UNITED STATES PATENT AND TRADEMARK OFFICE

10/646,545

Office Action Summary	Application No. 10/646,545	Applicant(s) HINE ET AL.	
	Examiner Alyssa M. Alter	Art Unit 3762

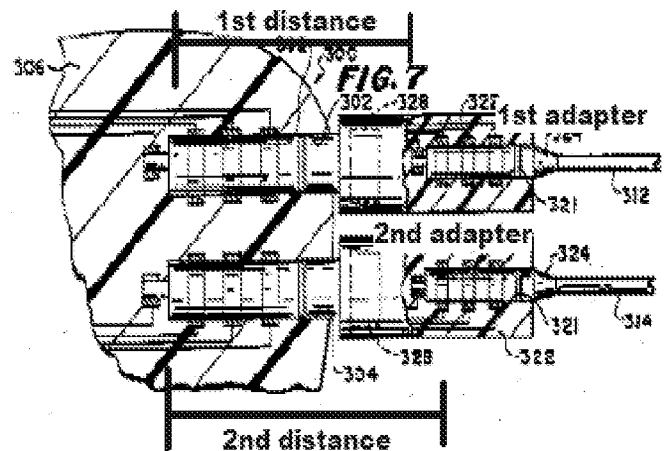
1. Claims 1, 3-4, 6, 11-13 and 15 are rejected under 35 U.S.C. 102(b) as anticipated by or, in the alternative, under 35 U.S.C. 103(a) as obvious Pohndorf et al. (US 4,628,934). Pohndorf et al. discloses a pacemaker with a connector bore for electrically and mechanically connecting the implantable medical device (IMD) with two adapters and multi-electrode leads as displayed in figures 6 and 7. The adapters upsize the leads prior to the insertion into the connector bore within the IMD. The array of lead connector elements are displayed in figure 2 as “sleeves 151 and 152 (in contact with

rings 141 and 142) (col. 7, lines 63-64)". The sleeves are connected to electrodes, with a conductor for each electrode. The two adaptors, which the examiner considers to be a plurality of adaptors, have an inner lumen for engaging the sleeves of the lead with rings to create an electrical and mechanical connection. In addition, the adaptors have an external surface used for engagement with the electrical bore. This engagement surface has two contact zones, the pin as the first zone and sleeves of the lead as the second zone, which connects within the IMD with the socket and rings, respectively.

As to claims 1 and 11, the examiner has included a replication of figure 7 to display the first and second distances. The examiner considers the first distance is to the first contact zone and the second distance is to the second contact zone. Therefore the first distance is not equal to the second distance.
